Section 16 Planning Application for Proposed Temporary Open Storage of Modular Integrated Construction Components and Construction Materials with Ancillary Workshops, Office, Staff Car Park and Machinery for a Period of 3 Years at Lot Nos. 1555 S.A (Part), 1555 S.B RP (Part), 1557 RP (Part), 1558 (Part) and 1559 (Part) in D.D. 107, Sha Po, Kam Tin, Yuen Long, New Territories (Planning Application No. A/YL-KTN/981)

We refer to the latest comments from Environmental Protection Department (dated 13.5.2024) and Drainage Services Department (dated 20.5.2024), and would like to enclose herewith our Responses-to-Comments Table to address the abovementioned departmental comments for their consideration.

Table | 1
Response-to-Comments

Figure 2-1 Buffer Distance Requirement from the Surrounding Roads

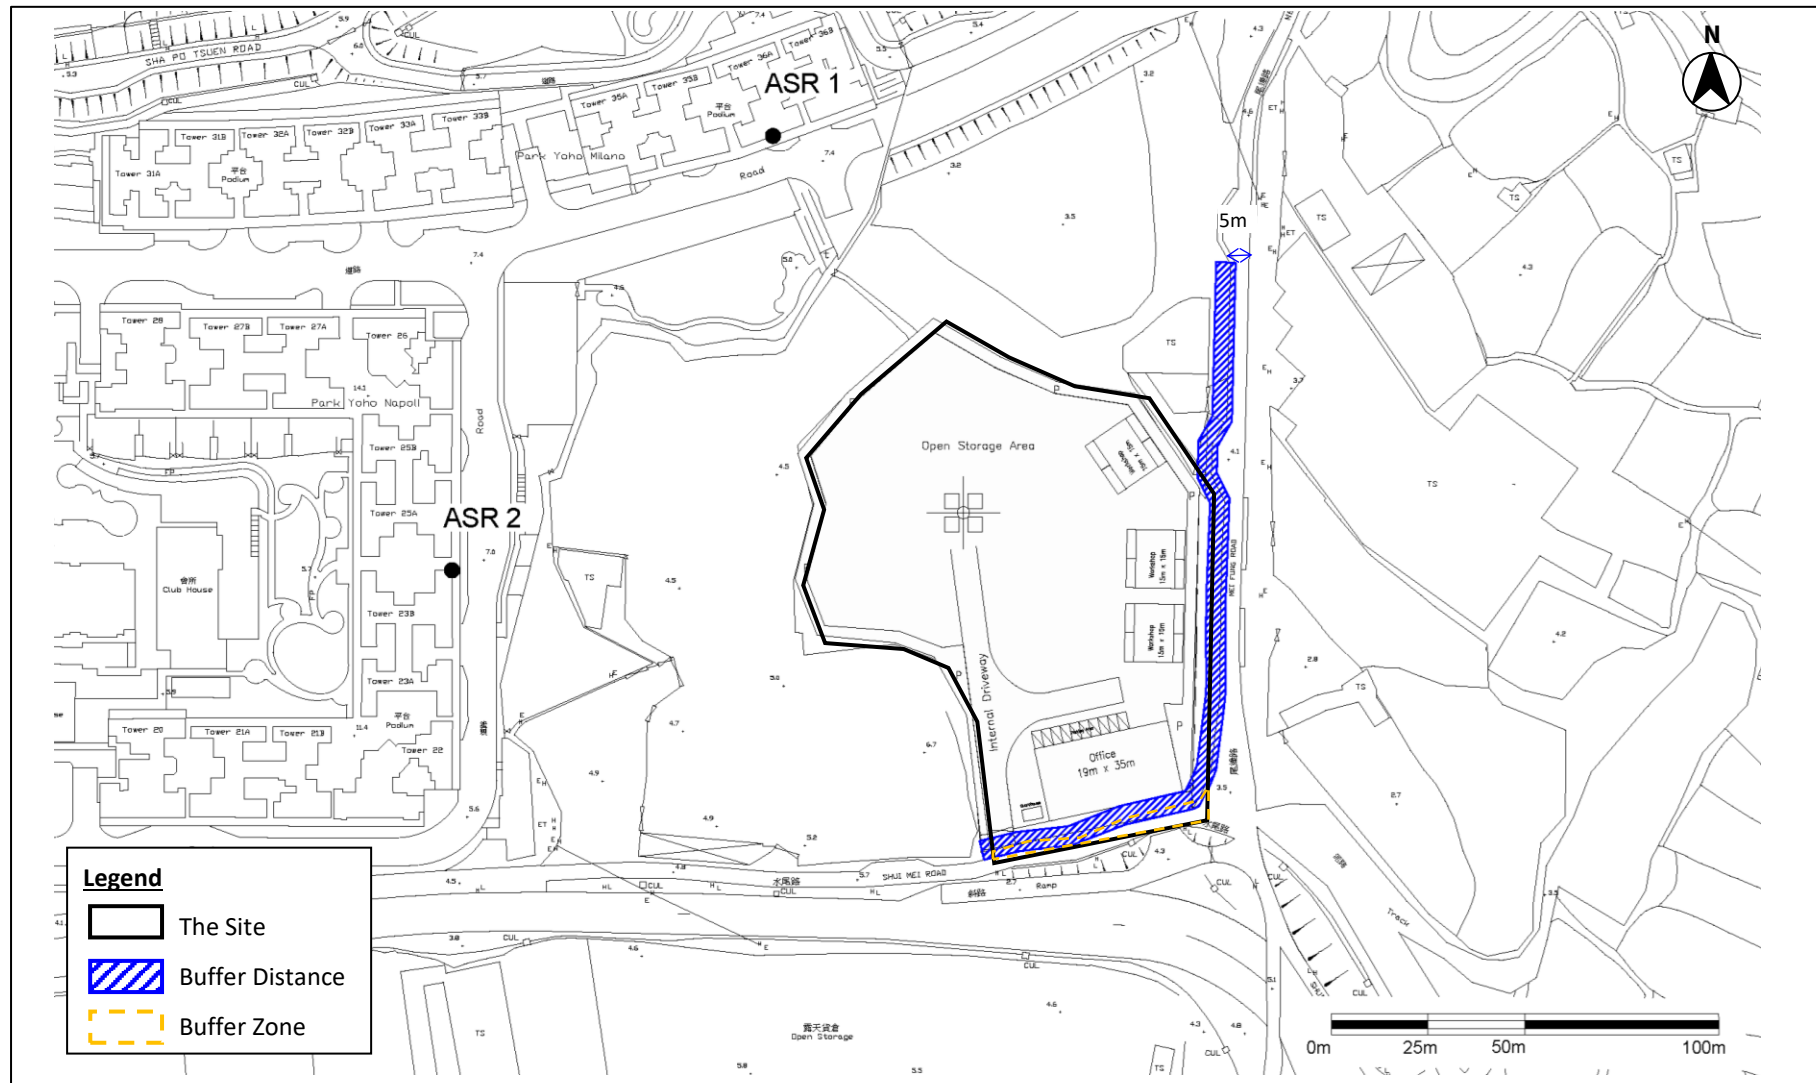
Comments	Response
assessment result as presented in the planning applications would be invalidated.	
6. Figure 2-1 – Please provide a remark to state that no air sensitive uses including openable window, fresh air intake and recreational uses in open space shall be located within the buffer zone.	Done
EA: Noise	
<p>1. General</p> <p>(a) The applicant shall be reminded that if so approved by TPB, the construction and operation of the Proposed Development is subject to the control of NCO and shall be further reminded the requirements to properly design and implement in accordance with the recommendations and requirements stipulated in HKPSG, ProPECC PNs and NCO. Fragmented presentations are very misleading and confusing, the consultant may consider to seek professional advice for reviewing the noise impact assessment.</p> <p>(b) Please clarify if there are any noisy activities within the proposed ancillary single-storey workshops. If affirmative, simply within the enclosed workshop may not be sufficient to demonstrate adequate noise reduction can be provided to alleviate the potential fixed noise impact from these operations, proper review and justification shall be provided to</p>	<p>Noted.</p> <p>There are no significant noisy activities within the proposed ancillary single-storey workshops which is mainly used for MiC unit assemble and finishing. Thus, limited equipment such as electrical drilling, polisher etc. will be used inside the enclosed workshop. As such the noise generated from the workshops is anticipated.</p>

Remark: There shall be no air sensitive uses including openable window, fresh air intake and recreational uses in open space within the buffer zone.

Figure C-1 Cross Section

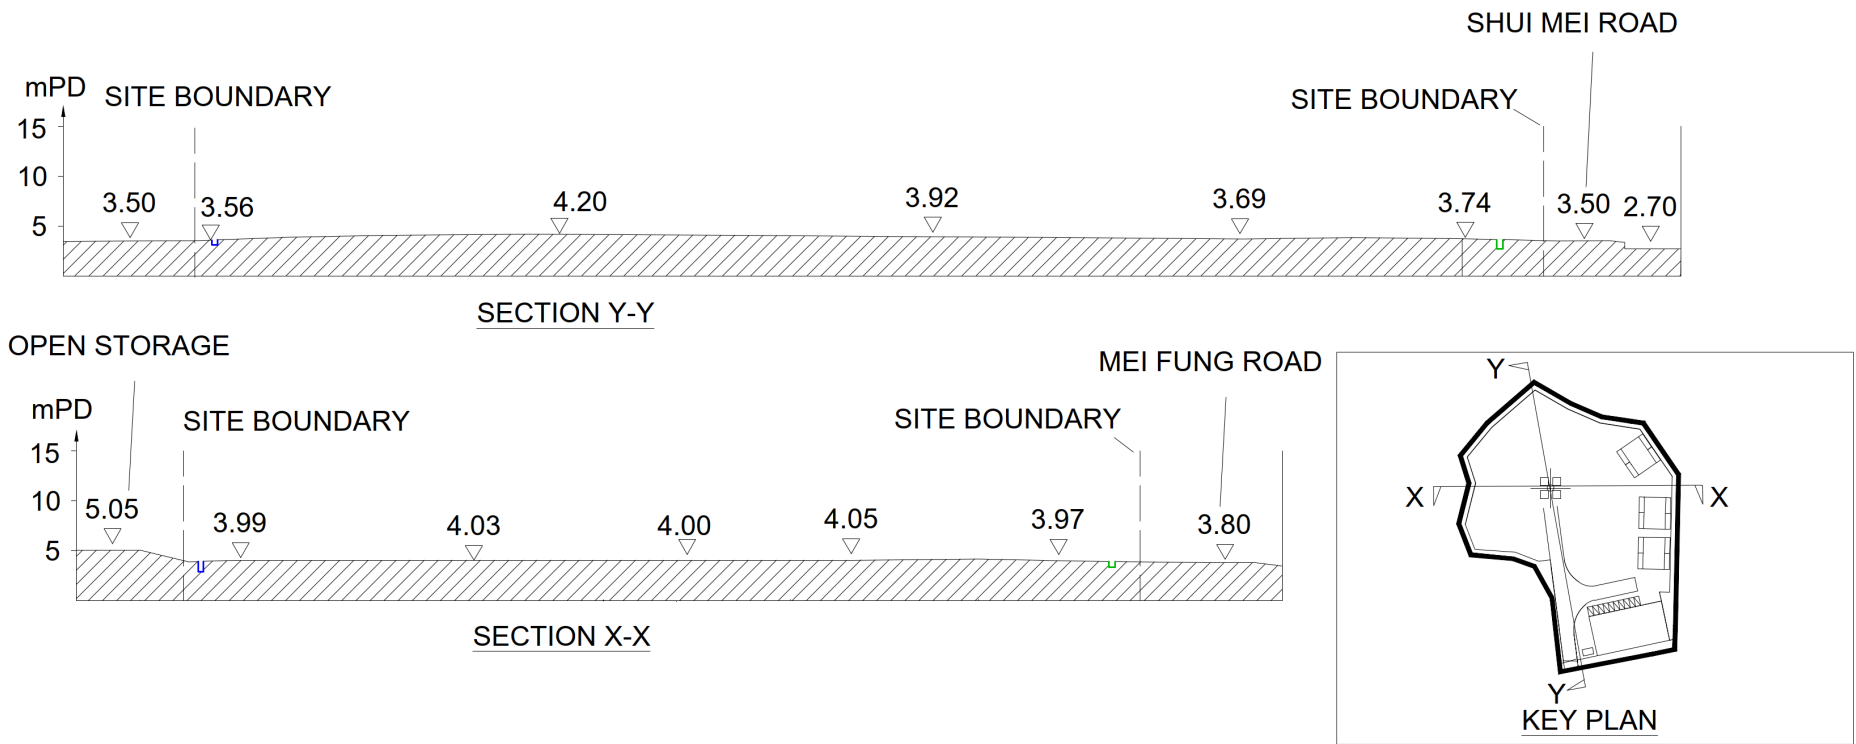
Comments	Response
From Drainage Services Department (DSD) (via email on 20 May 2024) on Drainage Proposal	
<p>3. Figure C-1: The drainage facilities presentation is incorrect. They should be shown as cross sectional view. Please revise to avoid confusion.</p>	<p>Figure C-1 has been amended to:</p> <ul style="list-style-type: none"> • show the cross sections of U-Channels on Sections Y-Y and X-X. • delete blocks not on the cut-lines X-X and Y-Y. • amend the axis of mPD. <p>As mentioned in para. 3.4.3 of the Drainage Proposal, the cross-section drawings are indicative based on the limited information which is mentioned in para. 4.1.4. An Updated Drainage Proposal including the cross-sections will be prepared based on the topographical data in the future.</p> <p>Bullet #2 of para. 4.1.4 has been amended to include update of Appendix C to avoid confusion.</p>
<p>4. According to the provided sections, external catchment areas should be considered in the assessment.</p>	<p>According to some elevations shown on topographical basemap downloaded from the Lands Department re-provided on Figure 3-1 of Drainage Proposal, the elevation the area to the north of the Site should be +3.5mPD which is lower than that of ~3.56mPD of the northern portion of the Site. Therefore, it is not likely for runoff overflowing from the areas to the north of the Site to the Proposed Development.</p> <p>For the areas to the east and south of the Site, they are separated by Mei Fung Road and Shui Mei Road. Based on the Site observations which can be verified by reviewing Street Views of Google Map, Mei Fung Road and Shui Mei Road are provided with road drains. Therefore, runoff from these areas including the roads is not likely overflowing to the Site.</p> <p>As mentioned in para. 3.2.1, drainage facilities should have been provided to the open storage to the west of the Site. Moreover, with reference to the topographic basemap from the Lands Department as shown on Figure 2-1, the catchment flow of the open storage to the west of the Site should be from East to West, which is away from the Site.</p> <p>Figure C-1 has been amended such that the area to the North of the site has a lower elevation. Please also refer to the revised para. 3.2.1 for details.</p>

Comments	Response
5. Figure C-1: Please review of the section markers are correct.	Figure C-1 has been revised.
6. Figure C-1: Please also indicate the relevant road/adjacent areas on sections for reference.	Shui Mei Road Mei Fung Road, and the Open Storage to the west of the site have been indicated on Figure C-1.
7. The 720mm cross road u-channel is considered not acceptable as the implementation and maintenance on site in future is not feasible. Please review the drainage proposal.	<p>The drainage proposal has been amended such that the 720mm cross road u-channel has been changed into a 750mm underground pipe.</p> <p>Please refer to the revised para. 3.4.2, Figure 3-2 and Appendix B for details.</p> <p>Furthermore, as recommended in para. 4.1.4, an Updated Drainage Proposal will be provided to include more detailed and updated information.</p>
